CLIENT: Comet Hatfield Construction Limited
CONSULTANT: STRIDE TREGLOWN
PROJECT: Hotel and Student Residential Comet Hotel Site

DRAWING TITLE
Comet Hotel - Ceiling section

SUITABILITY STATUS	SCALE
D3 : SUITABLE FOR CONTRACTOR DESIGN	As indicated @ A2
PROJECT ORIGINATOR ZONE LEVEL TYPE ROLE CLASSIFICATION NUMBER	REVISION
COMET-STL-00-ZZ-DR-A-ZZZZ-33002	C190

Comet Hotel - Section AA - Ceiling heights
1 : 50

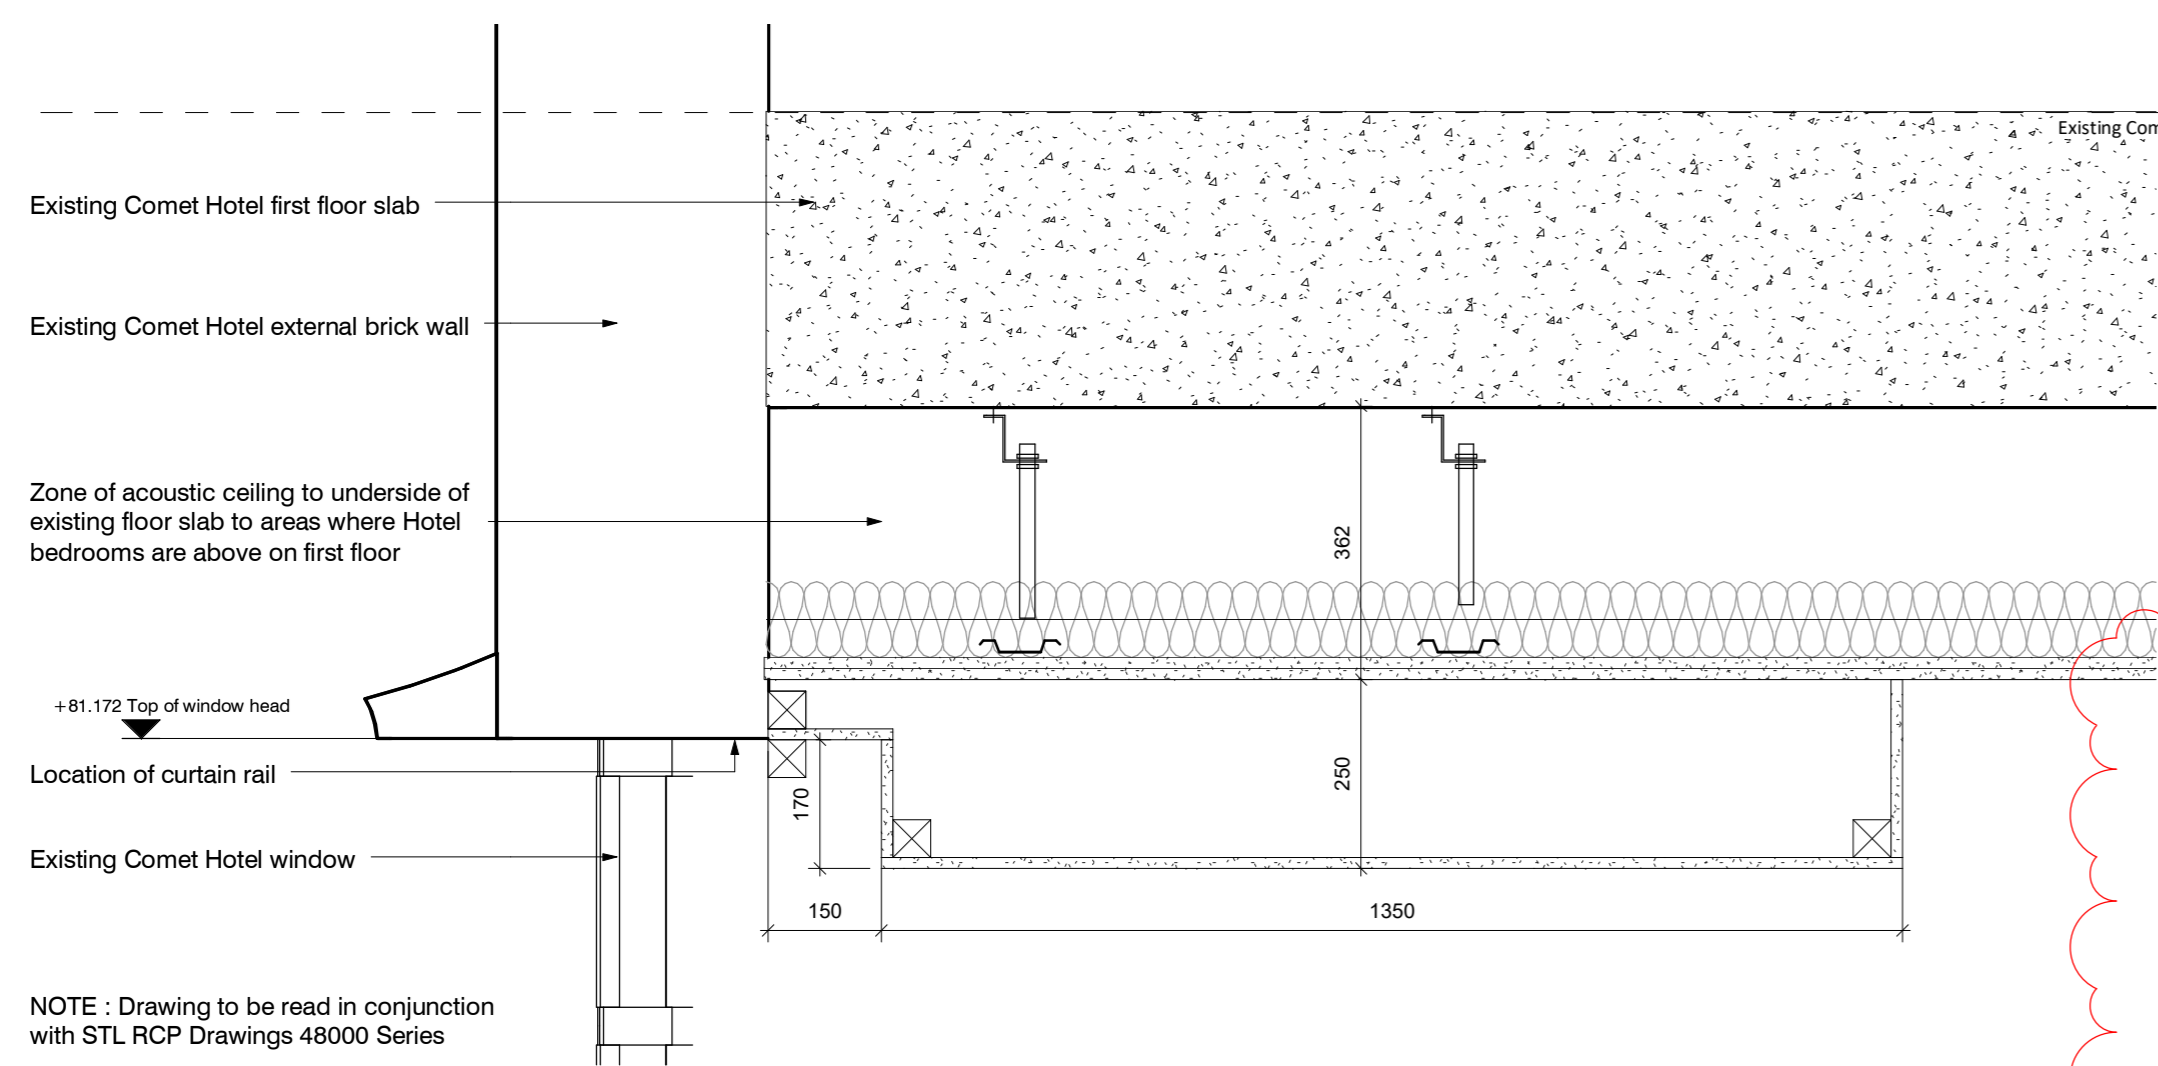
C190
Plenum upstand added, bar indicated and patrix above ceiling for stemware rods required

Comet Hotel - Section AA - Ceiling heights - Callout 1
1 : 10

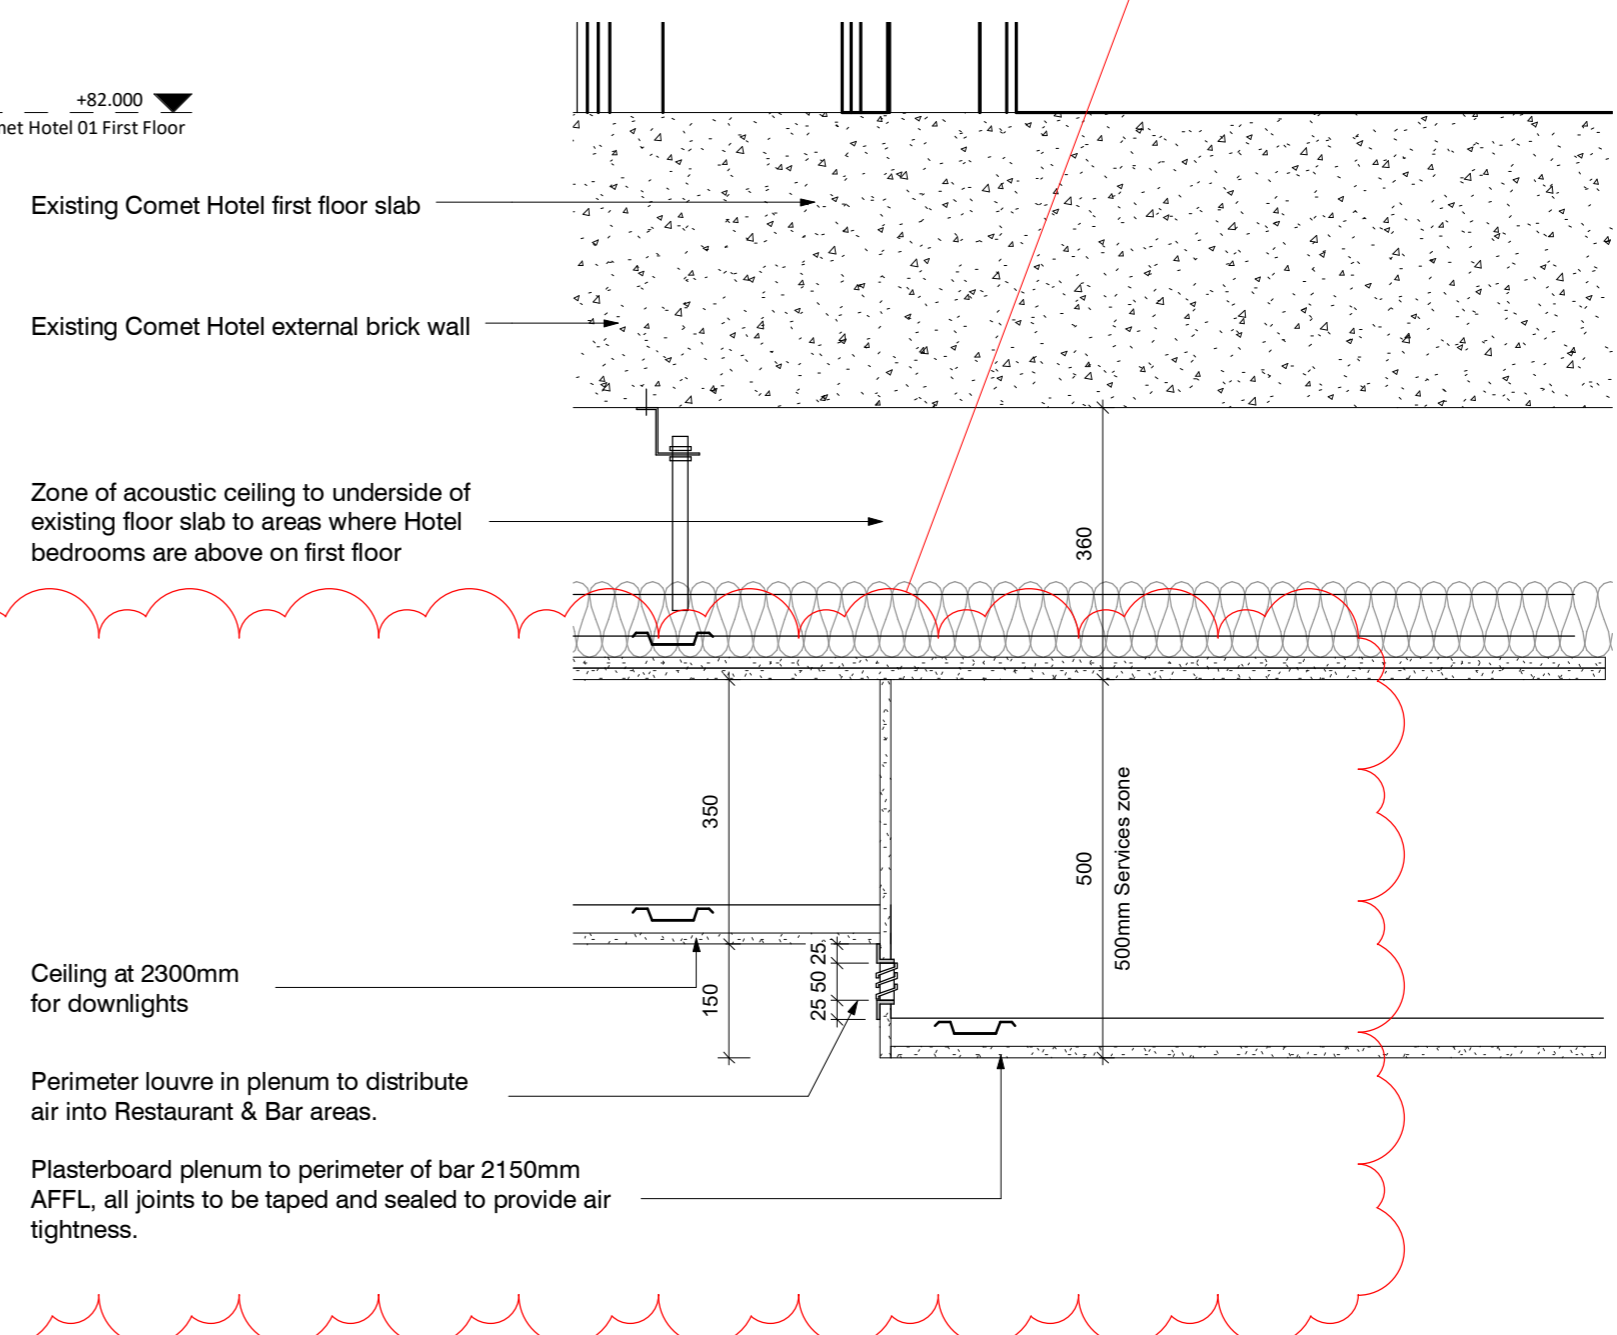
C190
Louvre to M&E details added to air tight plenum

Ceiling at 2300mm for downlights

Perimeter louvre in plenum to distribute air into Restaurant & Bar areas.

Plasterboard plenum to perimeter of bar 2150mm AFFL. all joints to be taped and sealed to provide air tightness.
